INCH-POUND
MIL-H-83511/6A
AMENDMENT 1
15 October 1999

HEADSET, ELECTRICAL, H-173C/AIC

This amendment forms part of Military Specification Sheet MIL-H-83511/6, dated 23 December 1981, and is approved by all Departments and Agencies of the Department of Defense.

Alternate locking thumbnut configuration.

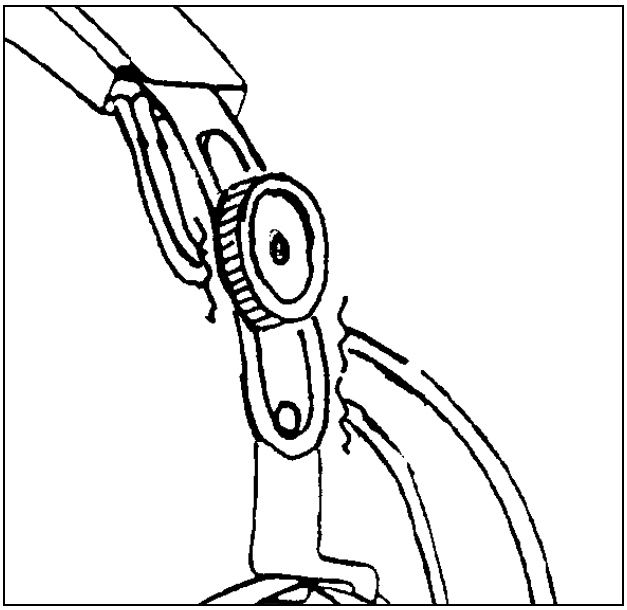
FIGURE 1: Add to Figure 1: Alternate configuration to the sliding action is a positive locking thumbnut.

FIGURE 2. Wiring diagram for H-173C/AIC

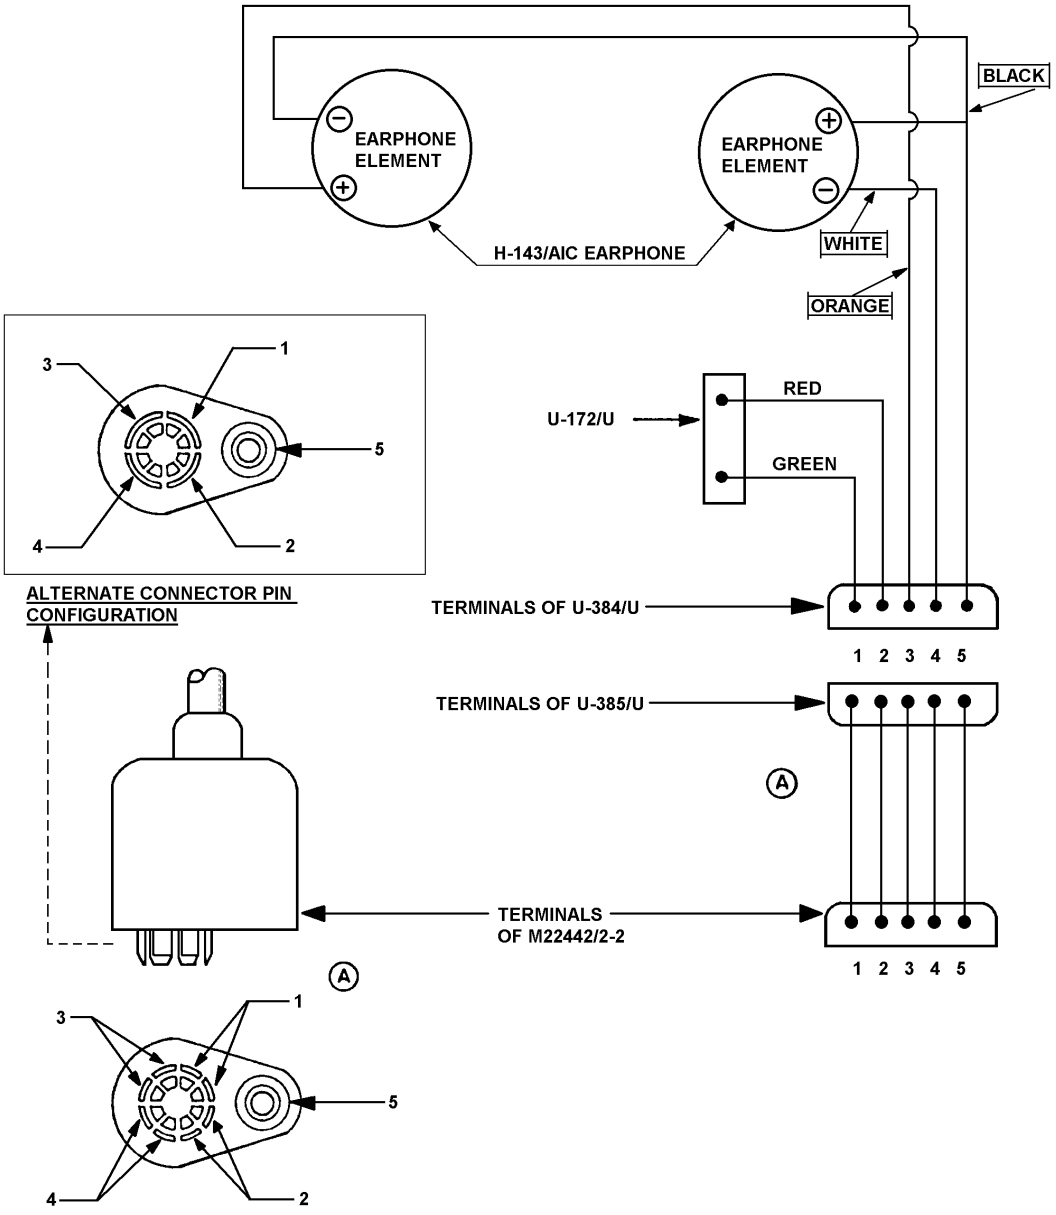
Figure 2: Delete and substitute:
